This is to certify that PEARL PROPERTY LLC / Joe Reynolds *Structure &*
has permission to addition of a 4 story building on footprint. *SHELL ONLY*
AT 61 INDIA ST *CBL 020 E021001*

City of Portland, Maine - Building or Use Permit Application

RE: **61 India Street (rear)**
Application ID: **#2008-0116 (approved October, 2008 as revised December 2008)**

C1.1
Revised 1/04

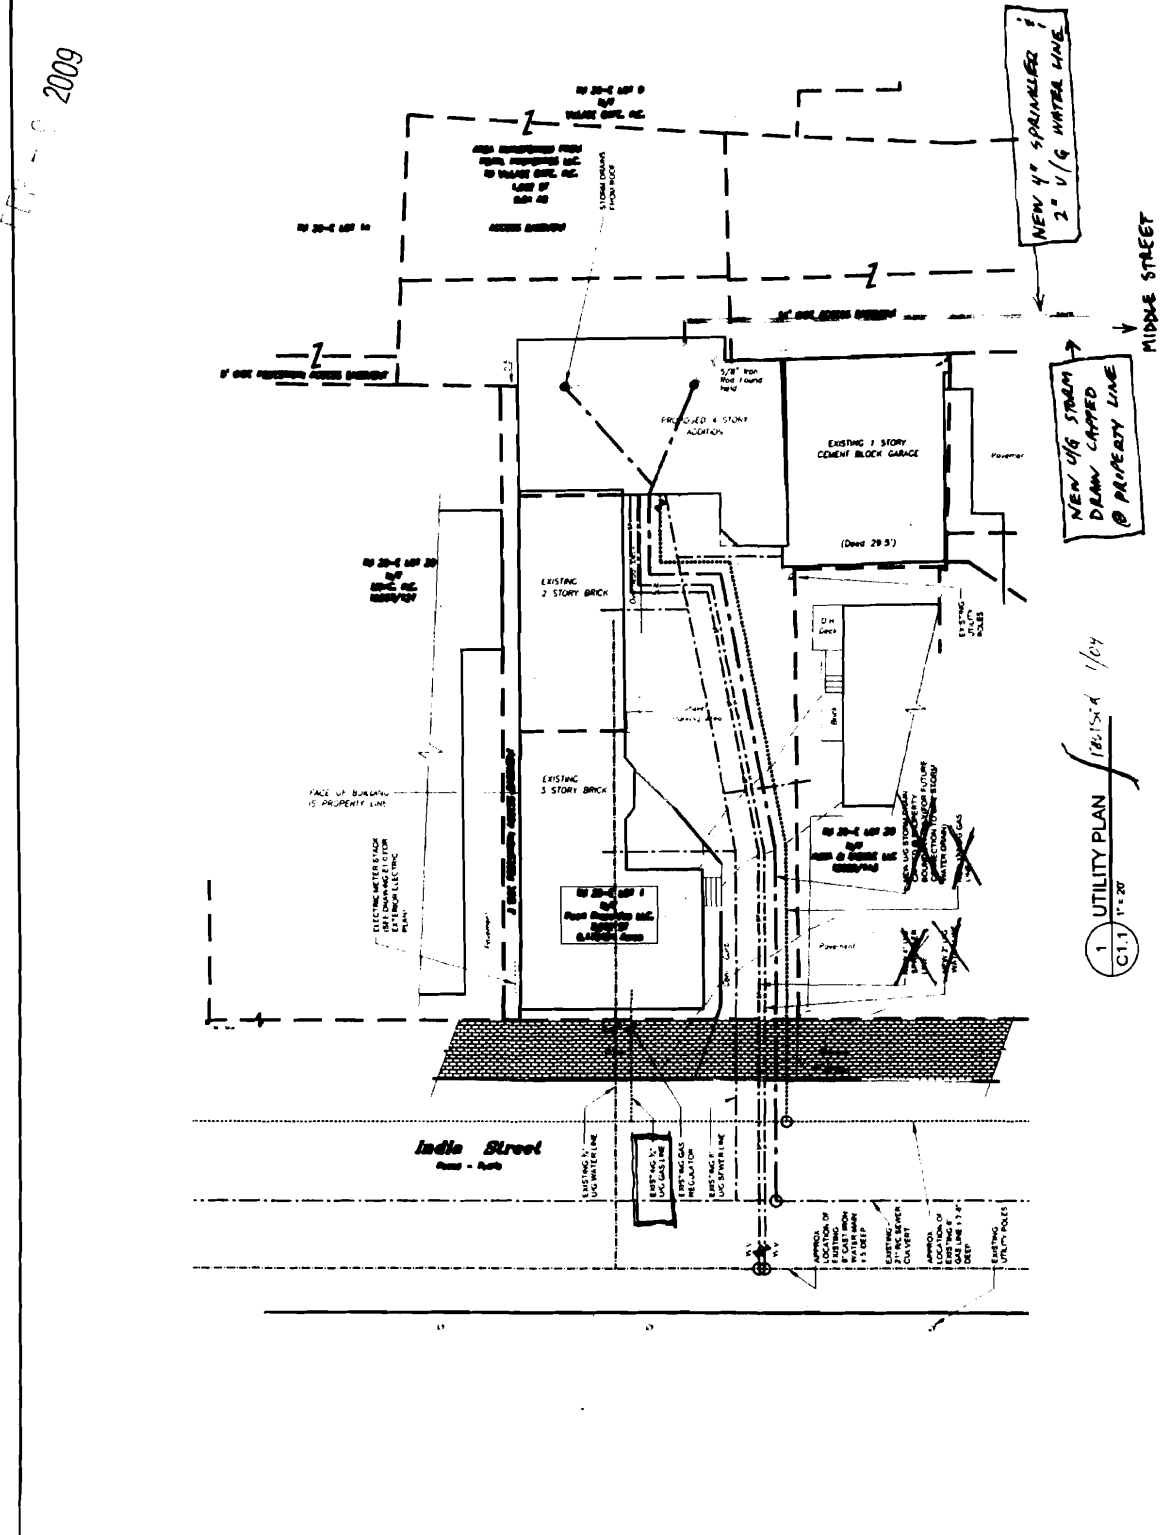
Thank you for letter and attached amended plan (hand annotated C1.1 Utility Plan "revised 1/09" showing revised locations of the water, gas and storm drain connections) dated January 28, 2009. I have discussed this proposed amendment to the approved project with Public Services Engineers and can confirm:

1. The City approves the relocation of the two water lines to tie into Middle Street and the use of the existing gas line in India Street (instead of the new gas line shown on the approved Utility Plan), and understand you will ensure the installations are acceptable to the relevant agencies.
2. The City approves the omission of the "New U/G storm drain capped @ property boundary" between the building and India Street.
3. The City does not require the "New U/G Storm Drain capped @ property line" shown on the amended plan between the building and Middle Street.
4. The City requires that the roof drains for the approved building construction shall discharge to the ground for surface flow and shall not be connected to the sewer lines in India Street nor in Middle Street.

This letter should be attached to the amended Plan C1.1 Utility Plan for future reference.

UTILITY PLAN
C1.1

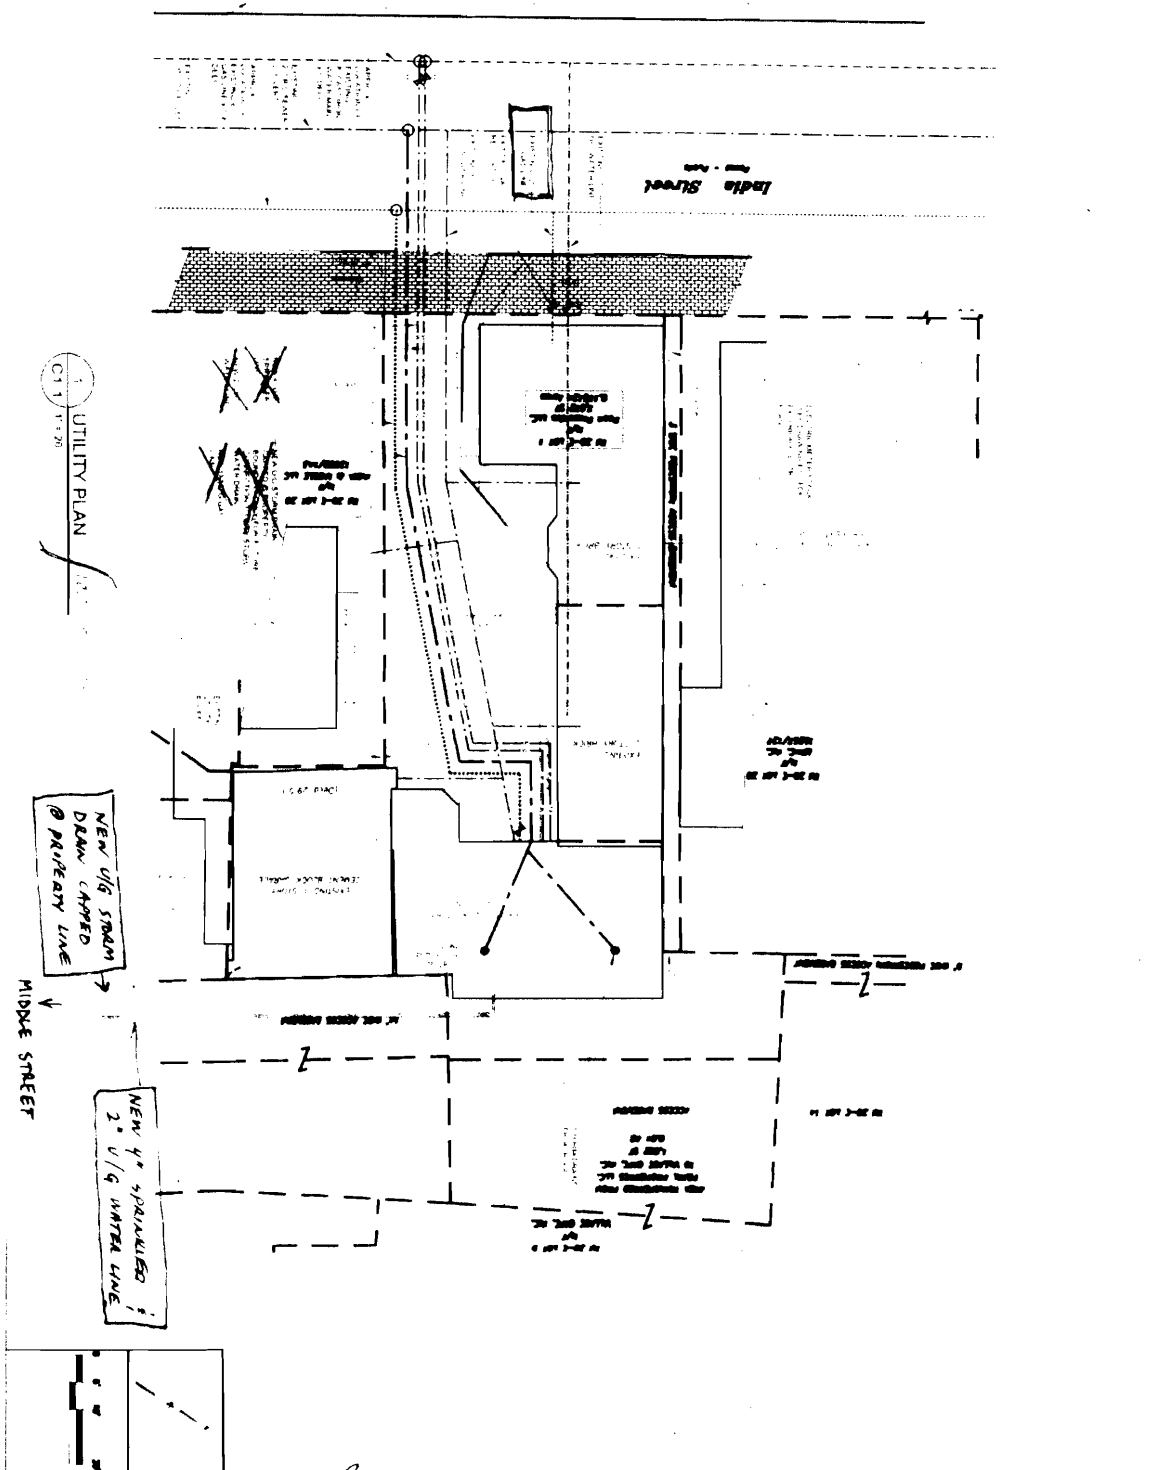
Thank you for letter and attached amended plan (hand annotated C1.1 Utility Plan "revised 1/09" showing revised locations of the water, gas and storm drain connections) dated January 28, 2009. I have discussed this proposed amendment to the approved project with Public Services Engineers and can confirm:

1. The City approves the relocation of the two water lines to tie into Middle Street and the use of the existing gas line in India Street (instead of the new gas line shown on the approved Utility Plan), and understand you will ensure the installations are acceptable to the relevant agencies.
2. The City approves the omission of the "New U/G storm drain capped @ property boundary" between the building and India Street.
3. The City does not require the "New U/G Storm Drain capped @ property line" shown on the amended plan between the building and Middle Street.
4. The City requires that the roof drains for the approved building construction shall discharge to the ground surface and shall not be connected to the sewer lines in India Street or to Middle Street.

This letter should be attached to the amended Plan C1.1 Utility Plan for future reference.

CITY OF PORTLAND
APPROVED SITE PLAN

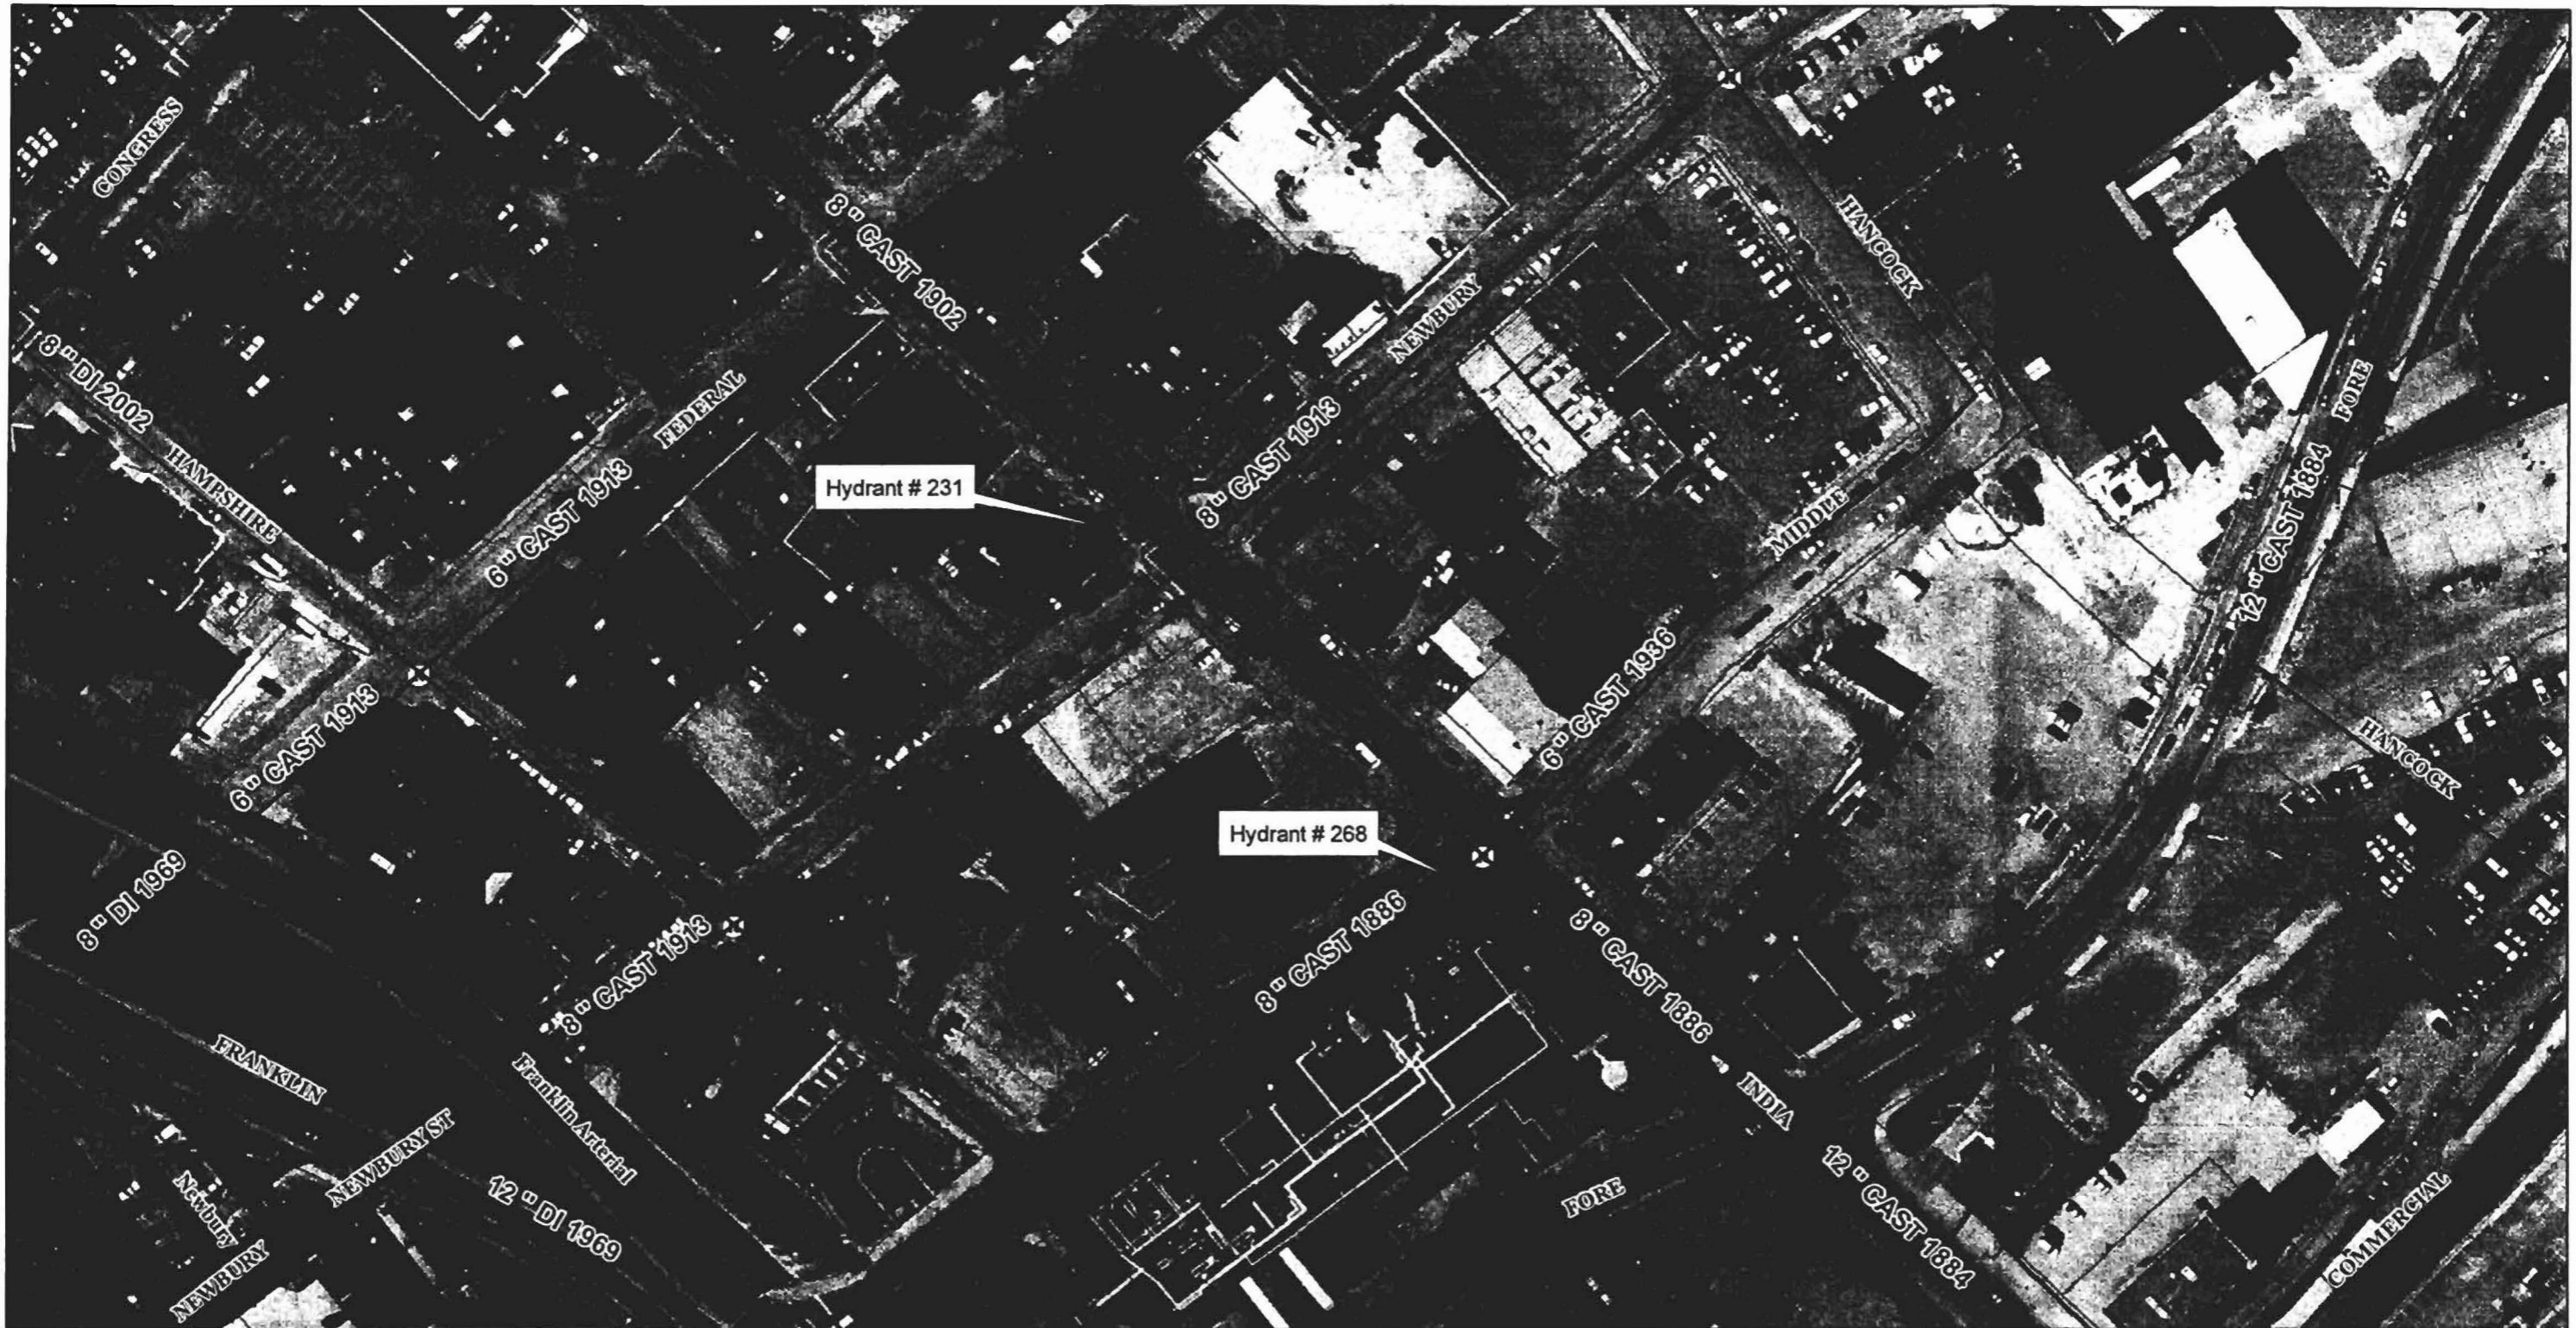
On October 6, 2008, the Portland Planning Authority approved a minor site plan for a four story infill building totaling 5411 sq ft floorspace, incorporating the remains of an existing structure of historic interest (3 story front elevation) at the rear of 61 India Street, as submitted by Pearl Properties LLC and shown on the approved plans prepared by TFH Architects and dated July 30, 2008 (Building Elevations and Floor Plans); September 19, 2008 (Utility and Landscape Plans) and October 1, 2008 (Site Plan with handwritten annotation), with the following conditions:

- i. That the proposed new building is limited to retail on the first floor, business on the second floor and a single residential unit comprising a total of 2695 sq ft on floors three and four; and
- ii. That there shall be no stubbing or roughing-in of plumbing and electrical for a "future" separate apartment on the top floor; and
- iii. That there shall be a building permit application for any change of use to add a new apartment; if this occurs within five years of the Certificate of Occupancy, an application for Subdivision Review shall also be submitted; and
- iv. That there shall be building permit applications for the actual tenants of the retail and office space for confirming use and for tenant fit-up; and
- v. That the applicant shall submit construction details of the "turntable" device, for the review and approval of the Planning Authority prior to its installation; and
